**PUR-1270
ADDENDUM NO. 5
INVITATION TO BID**

CONOCOCHEAGUE TREATMENT PLANT ENR UPGRADE

DATE: Thursday, May 26, 2016

DRAWING NO. S-13
 SHEET NO. 111 OF 327
 SP-15-028

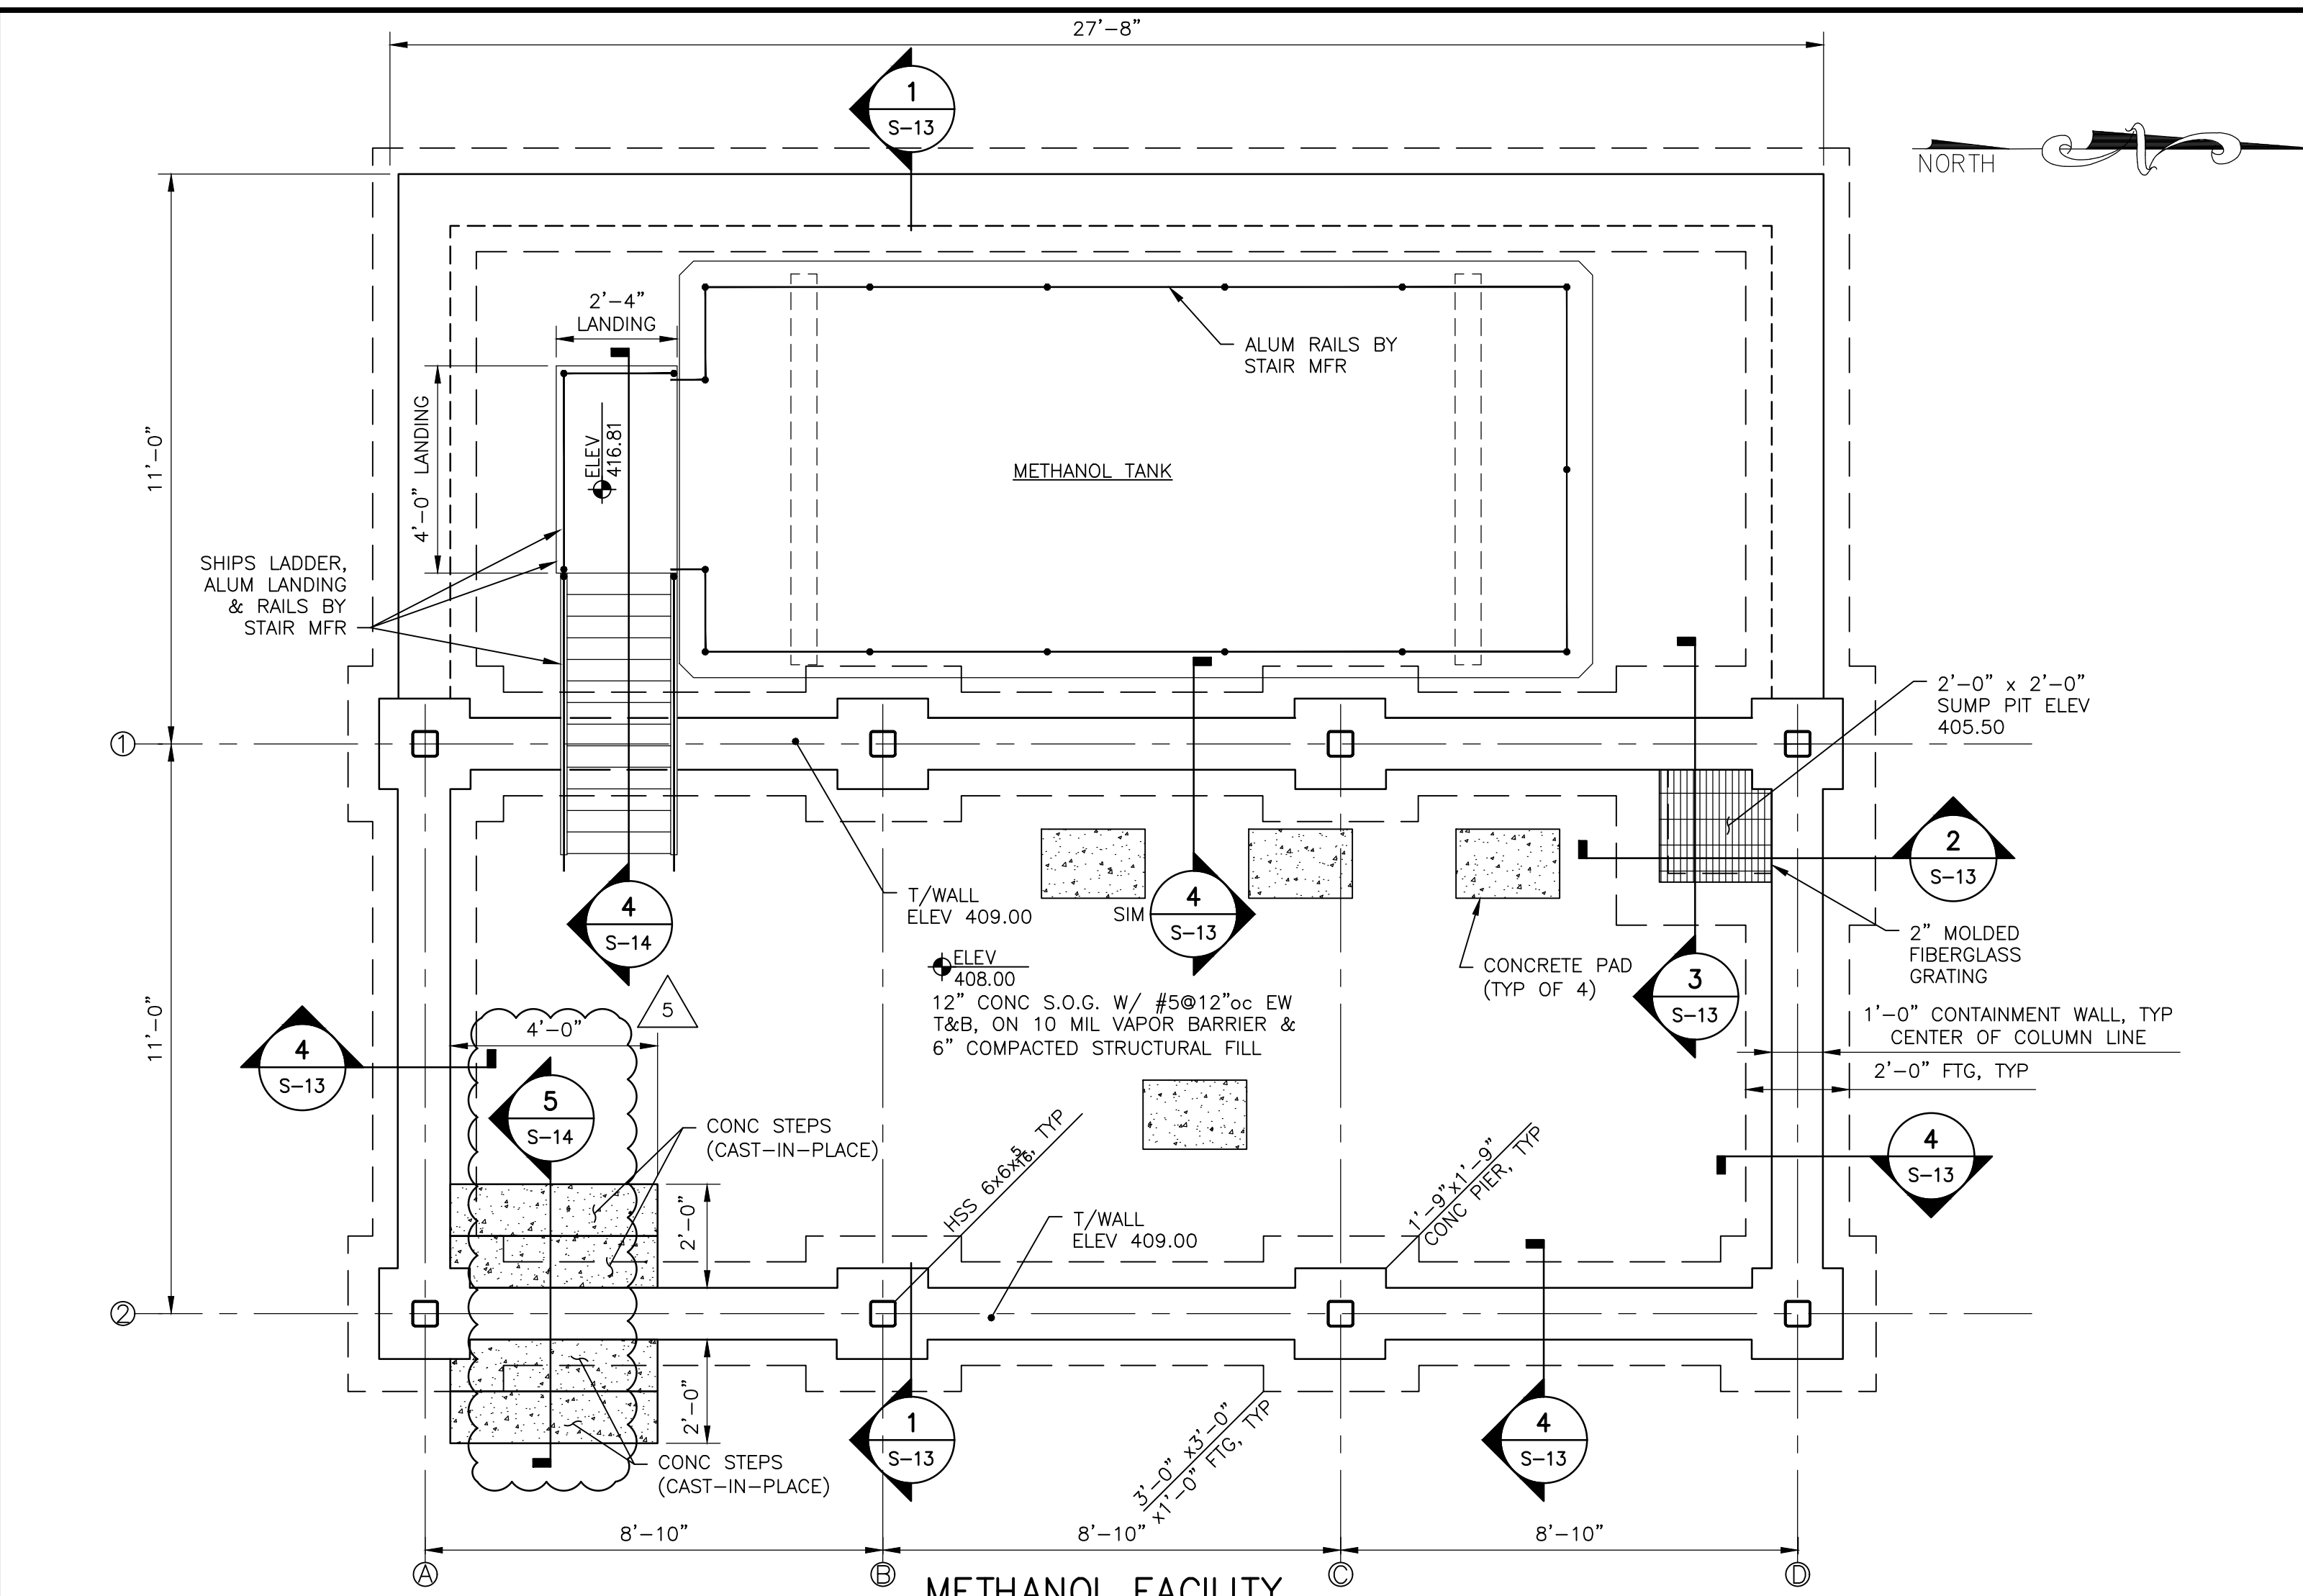
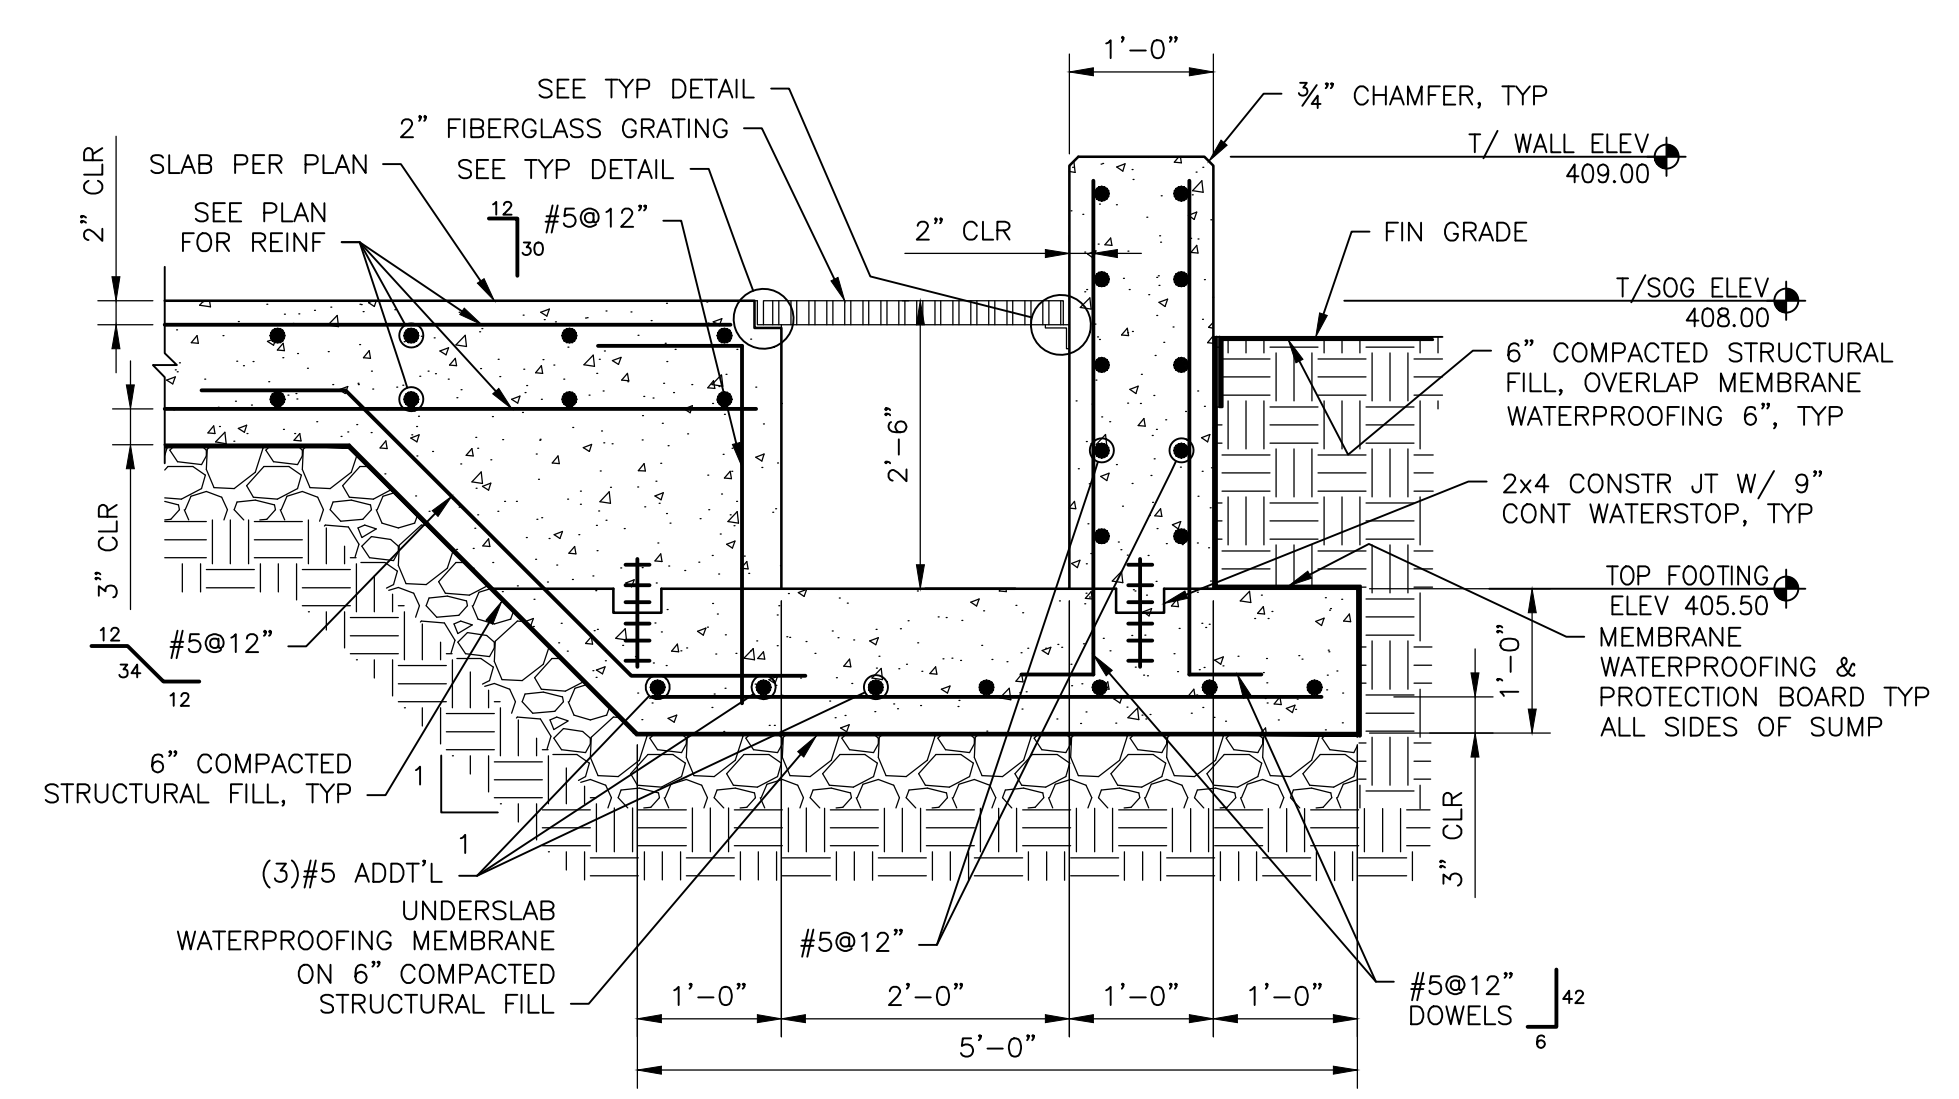
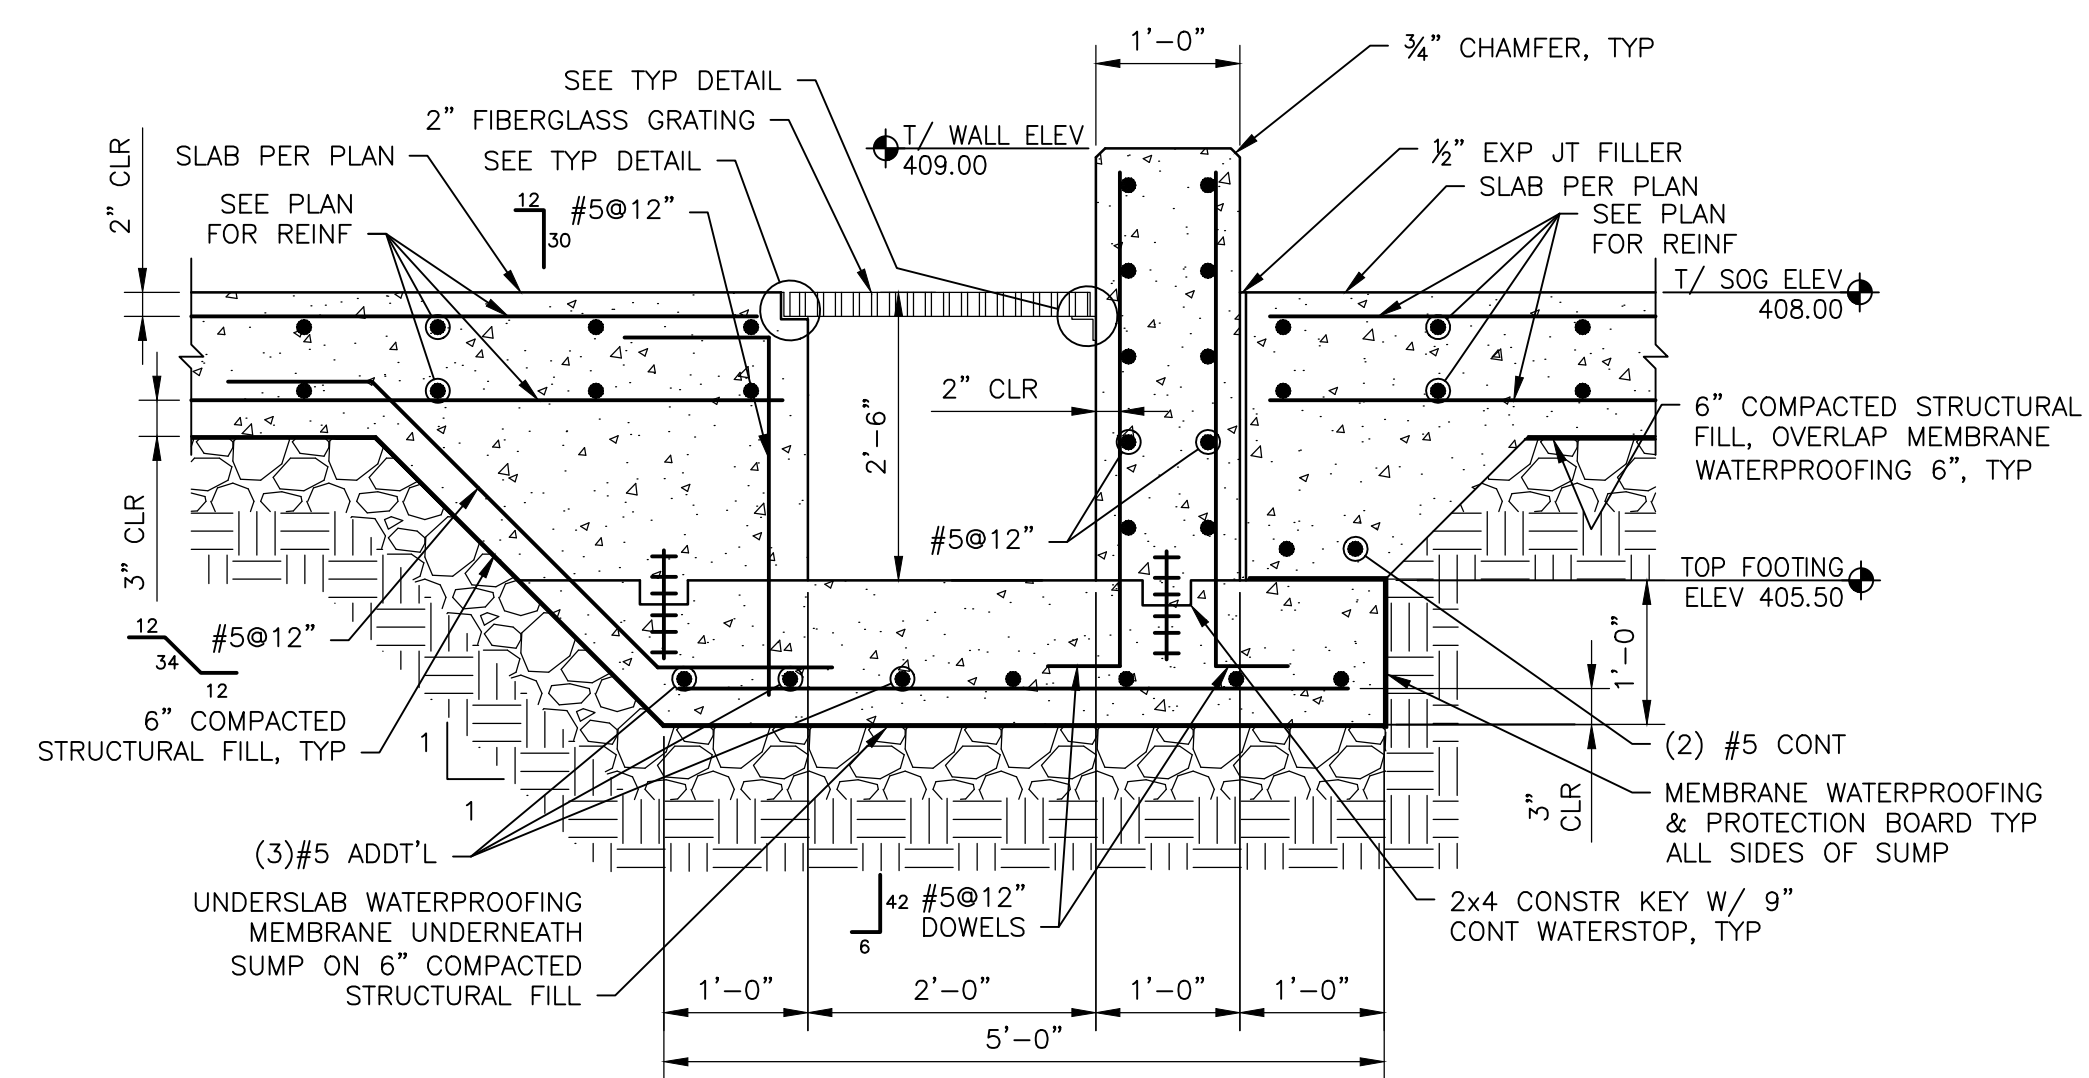
ITEM NO. 5: *Inquiry:* Drawing PM-22 shows a concrete stair outside of the footprint of the Methanol structure with no below grade support. Please provide information for the foundation for this stair.

Response: See revised Sheets S-13 and S-14 attached to this Addendum.
